**Economic and Social Council**Distr.: General  
3 March 2023

**World Forum for Harmonization of Vehicle Regulations****Working Party on Passive Safety****Seventy-third session**

**UN Global Technical Regulation No. 9 (Pedestrian safety)****Proposal for Amendment 3 to UN Global Technical Regulation No. 9 (Pedestrian safety) \*****Submitted by the Chair (Republic of Korea) of the Informal Working Group on the Deployable Pedestrian Protection Systems of UN Global Technical Regulation No. 9**

"Figure 11  
**Detection Test Area (see paragraph 3.19)**

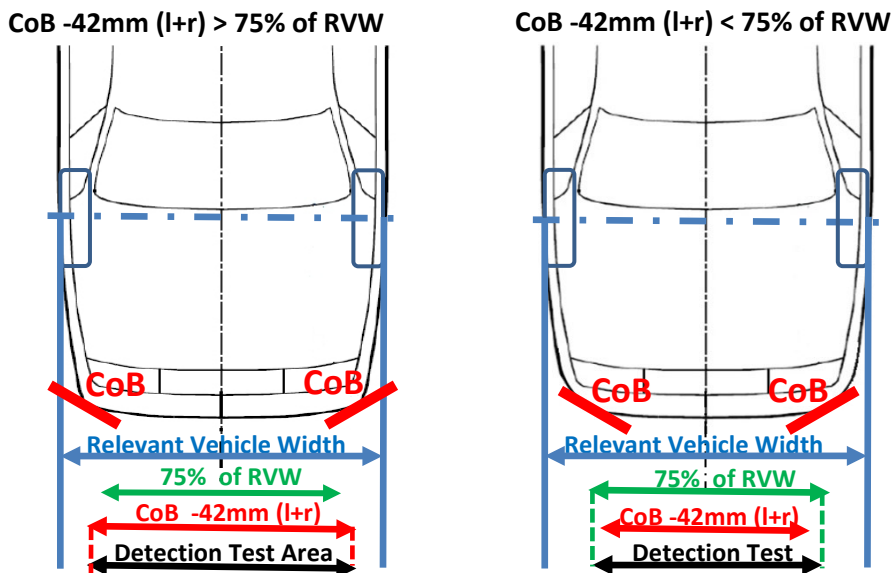
Insert new Figure 11, to read:

Figures 11 to 30 (former), renumber as Figures 12 to 31.
